Service Bulletin

Height Control Valve

CBXA40 Height Control Valve Upper Bracket Position

October 2017

Figure 1

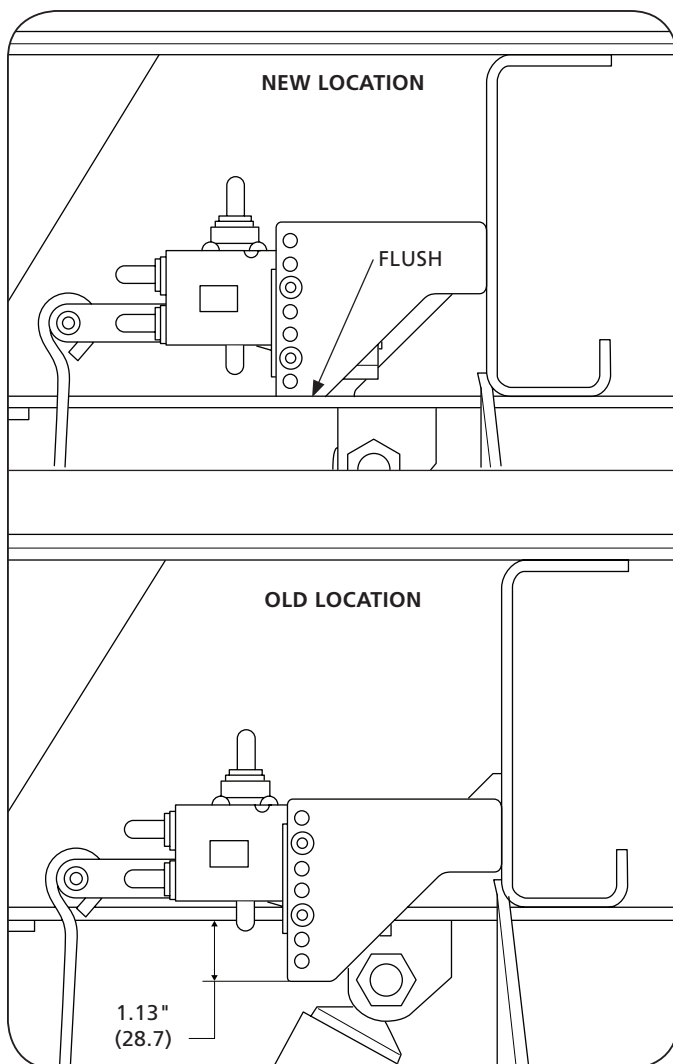
CBXA40 built between the dates of September 1st 2017 thru October 4th 2017 may have the HCV bracket installed improperly. Units affected may have ride height set lower than intended. SAF-HOLLAND® has developed the following instruction to address these units.

- Determine the location of the height control valve (HCV) upper bracket (**Figure 1**).
- If the HCV bracket is located 1.13" below the slide box frame rail (OLD LOCATION), no revision to the ride height should be necessary. Use the chart below to determine the appropriate HCV position based on ride height (**Table 1 and Figure 2**).

Figure 3

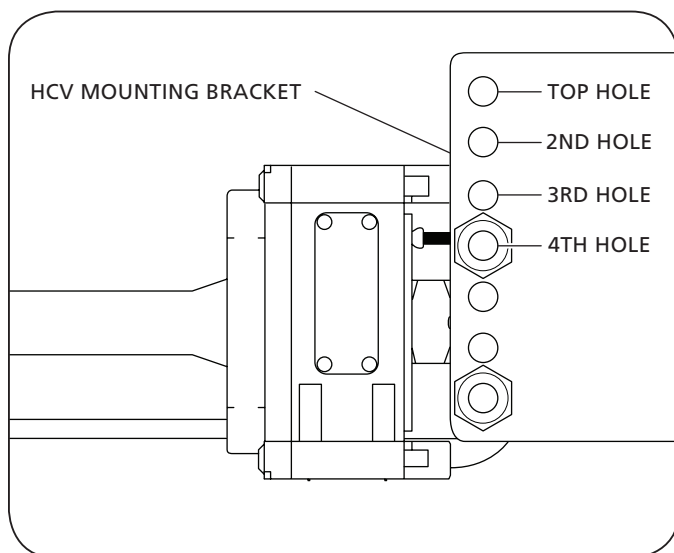
- If the HCV bracket is located flush with the slide box frame rail (NEW LOCATION), proceed to next step below.
- Replace 15" HCV double loop link with 16" HCV double loop link (SAF-HOLLAND Part Number 90560125).
- Reposition the HCV using **Table 2 and Figure 3**.
- With the HCV in the new location and the 16" double loop link installed check the ride height and make adjustments to be within $\pm 0.25"$ (**Figure 4**).

MOUNTING HOLE	"A" RIDE HEIGHT	
	INCH	MM
2ND	N/A	N/A
3RD	16.00"	406.4
4TH	16.50"	419.1
4TH	N/A	N/A
